Access Compliance Report

Public Rights-of-Way

Intersection ID: 3125	Main Street: JOHNSTON_OEHLER_RD	Cross Street: MOURNING_DOVE_LN	Location: SE
ADA ID: 80F27BEE99E1	Ramp Type: Combination1	Initial Pass/Fail: Fail	Overall Compliance: No
		Severity Score: 12.5

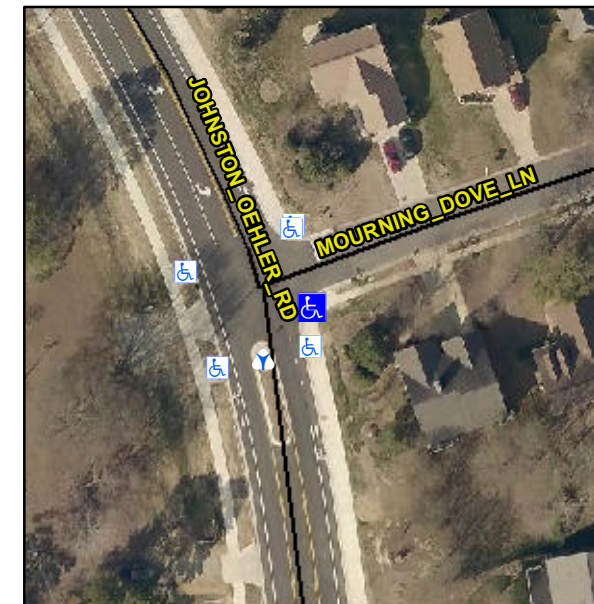
RT RP < 5%

Not Found, R304.2.2, R304.3.2

Compliance	Description	Data	Compliance	Description	Data
N/A	Ramp Length LT (in)	38.0	N/A	Ramp Length RT (in)	31.0
Yes	Ramp Width LT (in)	90.0	Yes	Ramp Width RT (in)	90.0
No	Ramp Slope LT (%)	9.4	Yes	Ramp Slope RT (%)	4.1
Yes	Ramp XSlope LT (%)	0.3	Yes	Ramp XSlope RT (%)	1.2
N/A	Ramp Length (in)	90.0	No	Ramp Slope (%)	10.2
Yes	Ramp Width (in)	48.0	Yes	Ramp XSlope (%)	0.4
N/A	Flare Type LT	N/A	N/A	Flare Type RT	N/A
N/A	Flare Slope LT (%)	N/A	N/A	Flare Slope RT (%)	N/A
N/A	Flare Traversable LT?	N/A	N/A	Flare Traversable RT?	N/A
N/A	Landing Length (in)	N/A	N/A	DWS Provided?	N/A
N/A	Landing Width (in)	N/A	N/A	DWS Contrast?	N/A
N/A	Landing Slope (%)	N/A	N/A	DWS Length (in)	N/A
N/A	Landing X Slope (%)	N/A	N/A	DWS Full Width?	N/A
N/A	Landing Curb? (Y/N)	N/A	N/A	DWS Offset (in)	N/A
N/A	Shared Landing?	N/A			
N/A	Gutter Ponding?	N/A	N/A	Gutter Slope (%)	N/A
N/A	Gutter Lip Ht (in)	N/A	N/A	Gutter X Slope (%)	N/A
N/A	Painted X Walk1?	No	N/A	Painted X Walk2?	N/A

Remove & Replace Entire Ramp.
